St. Francis Neighborhood Center-Phase Two (SNFC-PH2)

RFI ATTACHMENTS

PROJECT : SNFC - PHASE-2
PROJECT#: #21005
DATE: 3/23/23
FROM: RM Sovich Architecture RMSOVICH@RMSARCHITECTURE.COM, Ftemelisso@rmsarchitecture.com

These attachments address questions by contractors, clarifications and revisions made after the drawings have been issued for bid and shall become part of the bid package for the above referenced project.

6'H IRON PRIVACY PANEL FENCE - ELEVATION

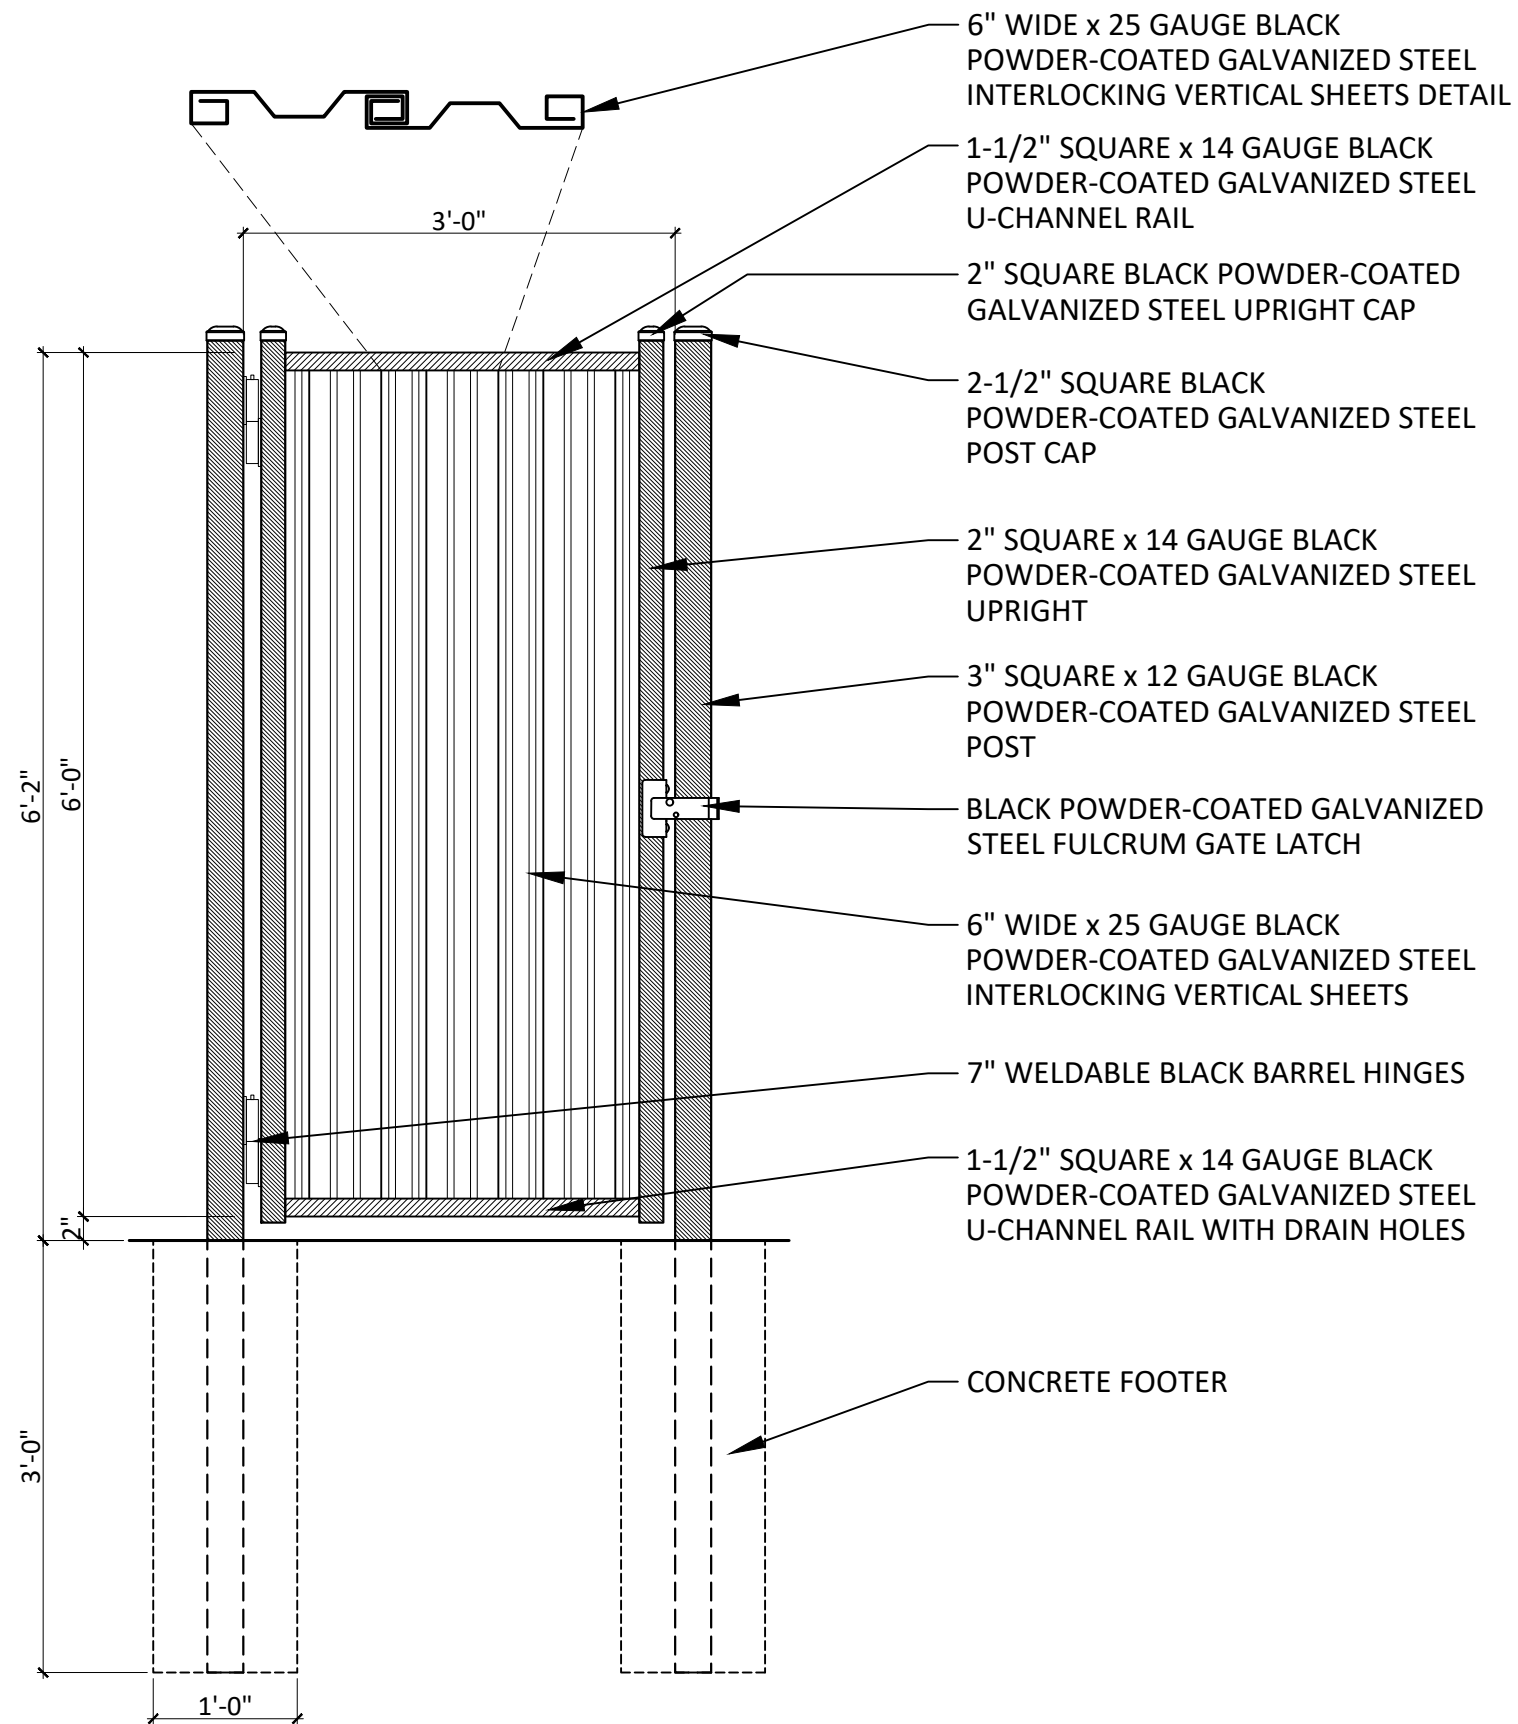
9.0	1	Michael Trionfo	3/17/23		SIT-2 and A100/A101	8. There is a difference on how much of the white iron fence and gate should be relocated between drawing SIT-2 and A100/A101. Which drawing should we use for pricing?				3/23/23			Architect	New Item	ADD#01
10	1	Michael Trionfo	3/17/23			9. On the drawings at the trash pad, there is fence and a note that the new fence is to match the existing fence on site, but there are two types of fence on site – the white iron and wood. Which one should be installed at the trash pad?				3/23/23	Please use six foot white iron fence as manufactured by LongFence. A cut sheet of a section is attached.	Spec	Architect	New Item	ADD#01
11	2	Kim Boyd	3/21/23		A602.	1. Please refer to the snip from Plan Page 14 - A602. The flooring as indicated, shows the RF-7 walk off mat in Classroom 222. However, the pattern indicates the Kinetex carpet tile. The carpet tile seems more likely. Should we assume this to be a labeling error?				3/23/23	We concur. Please use the Kinetex carpet tile pattern.		Architect	New Item	ADD#01
